# CONTRACT

PROJECT: SB-IA-2100(675)--7T-31

LOCATION: BEE BRANCH CREEK IN THE CITY OF DUBUQUE MISSISSIPPI RIVER TRA  
IL

Make the following changes to the plan:

Plan Sheet U.34

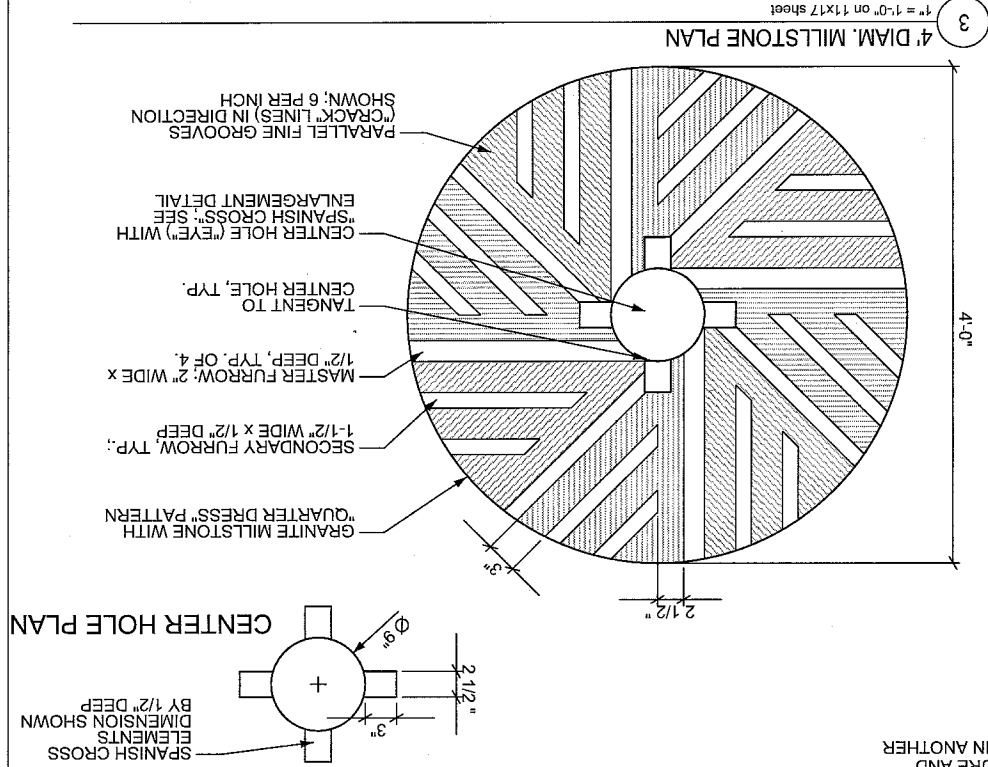
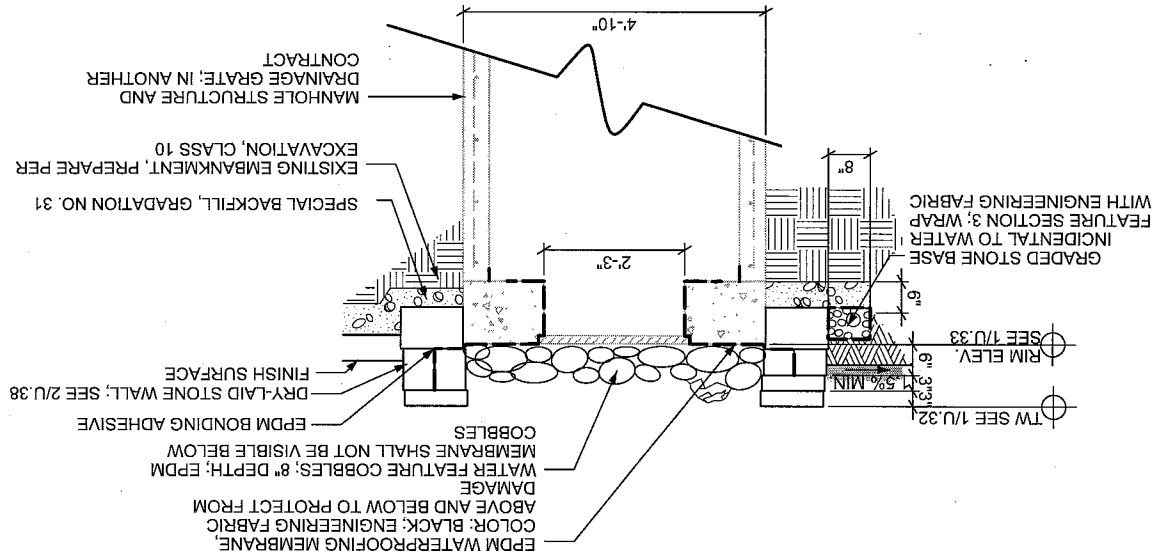
Replace the following text within DETAIL 1 WATER FEATURE SECTION 1:  
MILLSTONE-WATERFALL:

From: 6" pipe w/bell end to support 100-300 GPM flow rate;

Seal millstone to pipe with elastomeric sealant,

Insert Neenah R-4270-1 type grate into bell end.
